ELECTRICAL—AFTERMARKET ACCESSORIES INOPERATIVE OR NOT OPERATING AS DESIGNED—POLICE INTERCEPTOR MODELS BUILT BEFORE 5/23/2002 ONLY	Article No. 02-15-1

FORD: 2003 CROWN VICTORIA

Figure 1 - Article 02-15-1

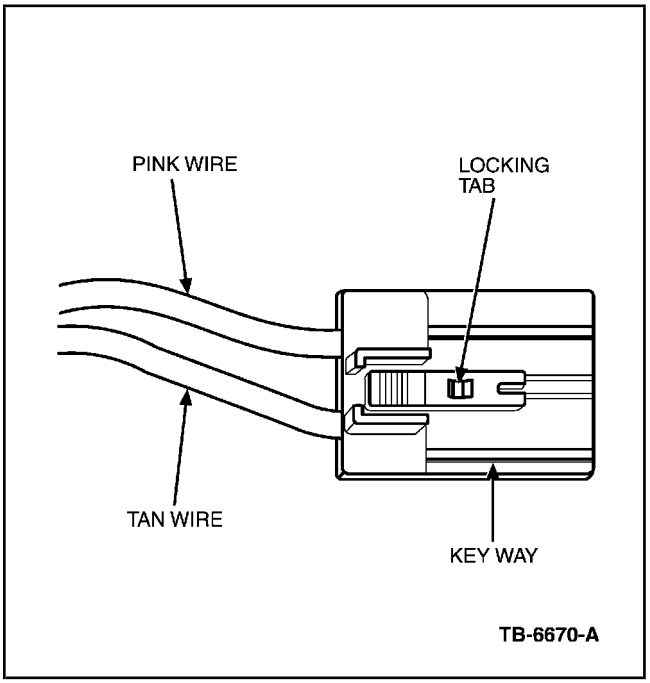
Some 2003 Crown Victoria Police Interceptors built before 5/23/2002 may have the tan and pink wires into electrical connector C2232d in the incorrect pin locations. These wires supply power to the optional police front power distribution box. The tan wire is hot at all times; whereas, the pink wire is hot with ignition in run. This may cause aftermarket police accessories intended to have power only with key on, to be powered at all times. Accessories intended to have power at all times, would have power only with key on.

Locate connector C2232d under the passenger side instrument panel. This connector supplies power to the optional police front power distribution box. Compare the wire locations to those shown in Figure 1. If the wires are in the incorrect pin locations, refer to the following Service Procedure for details.

5. Grasp the connector with one hand and use the screwdriver to depress the locking pin inside the connector to release the terminals.
6. Switch locations of the terminals to match Figure 1.
